USB 3.0 ENGINEERING CHANGE NOTICE

ECN# 011

Title: USB3.0 Peripheral USPort State Machines ECR

Applied to: USB3.0 (11132008)-final

(a). Amendments proposed to Section 10.5 (Figure 10- 11)

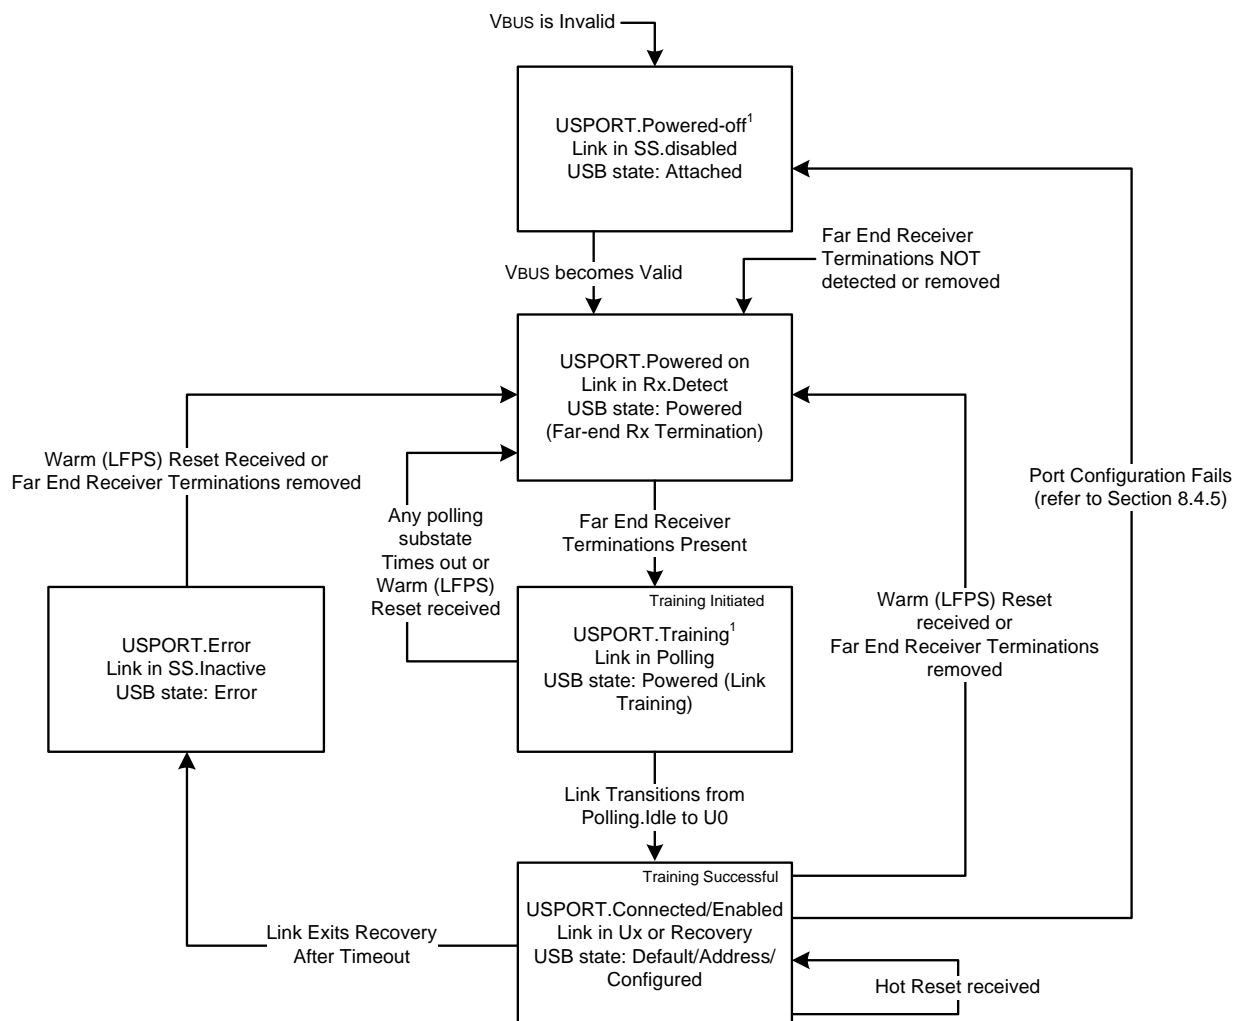
Replace current Figure 10-11 in Section 10.5 with the figure below:

Made a change to bring the state machine in sync with the LTSSM description in chapter 7 (and figure 7-16).

- Updated the Arc from USPort.training to USPort.powered-on to include “warm(LFPS) reset”.

¹ If Port Configuration fails, the port shall transition to the USPORT.Powered-off state with the link in SS.Disabled state and USB Device in the Attached state. Vbus may still present on the upstream port. Vbus must be toggled to transition to the USPORT.Powered on state.

Figure 10-15. Peripheral Upstream Device Port State Machine

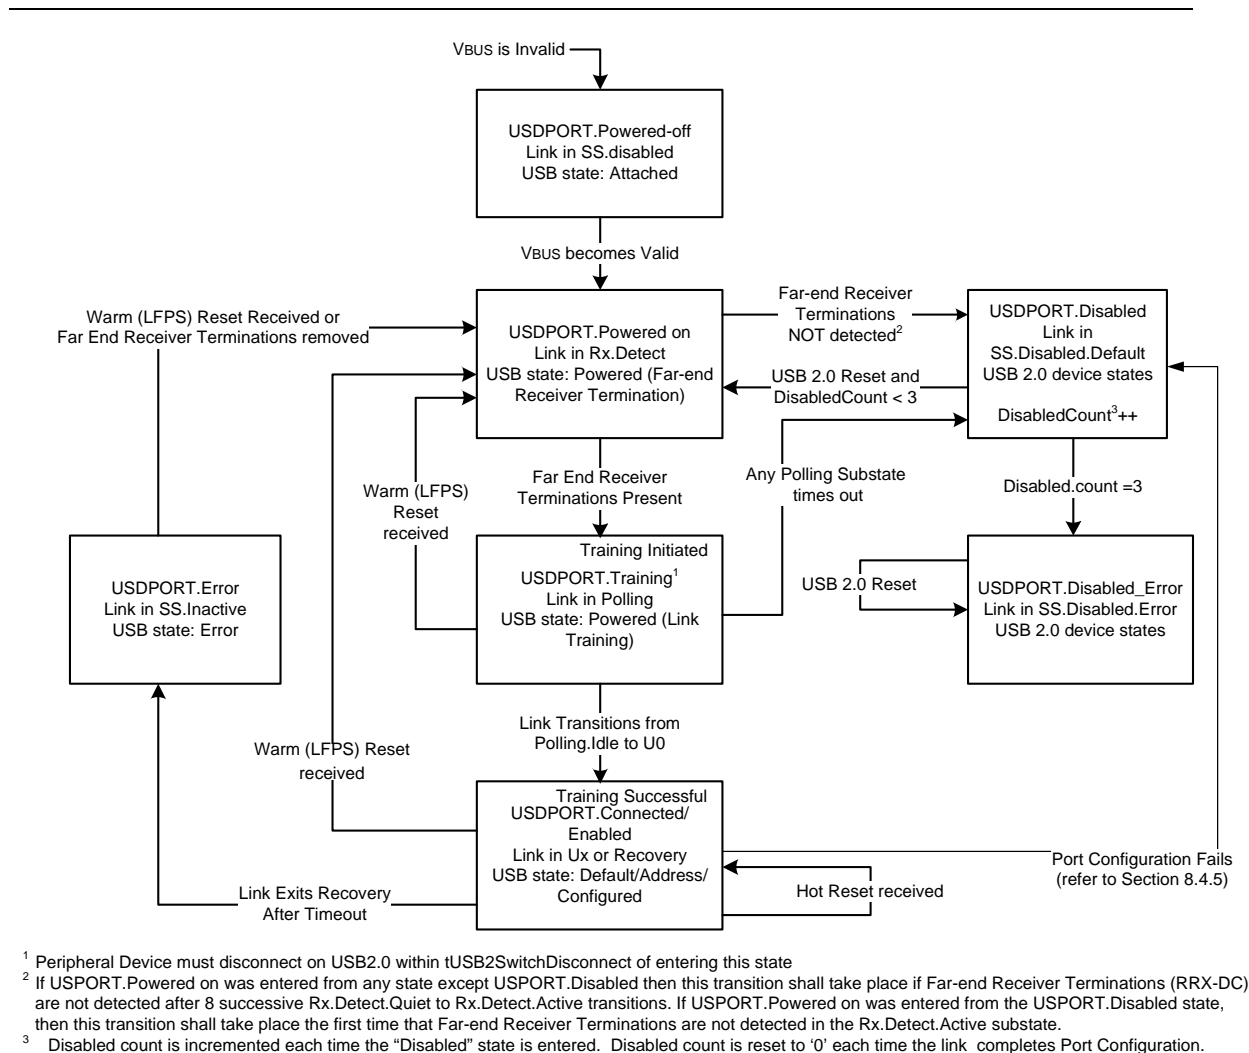
(b). Amendments proposed to Section 10.16.2 (Figure 10-25)

Changes to the Upstream Port State Machine:

- Added arc from USDPort.Training to the USDPort.Powered On state to make this state machine consistent with the LTSSM Polling Substate Machine (figure 7- 16).
- Made changes corresponding to the changes in the text in sections 10.16.2.6 and 10.16.2.7

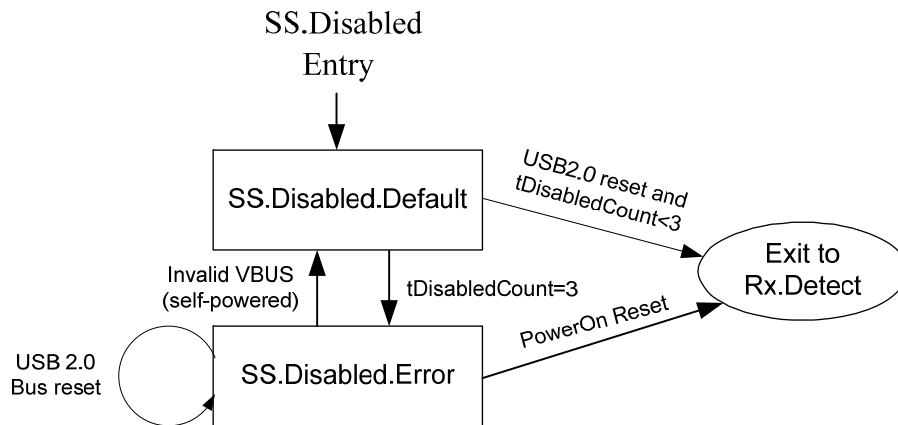
SS.Disabled of a peripheral device has two substates shown in Figure 7-14.

- SS.Disabled.Default
- SS.Disabled.Error

- A peripheral upstream port shall transition to Rx.Detect if one of the following conditions are met.
 1. When VBUS transitions to valid.
 2. When a USB2.0 bus reset is detected and tDisabledCount is less than 3.
- A peripheral upstream port shall transition to SS.Disabled.Error if tDisabledCount is 3.

- A peripheral upstream port shall transition to Rx.Detect upon PowerOn reset.
- A self-powered peripheral upstream port shall transition to SS.Disabled.Default upon detection of invalid VBUS.
- A peripheral upstream port shall remain in SS.Disabled.Error upon detection of USB 2.0 bus reset.
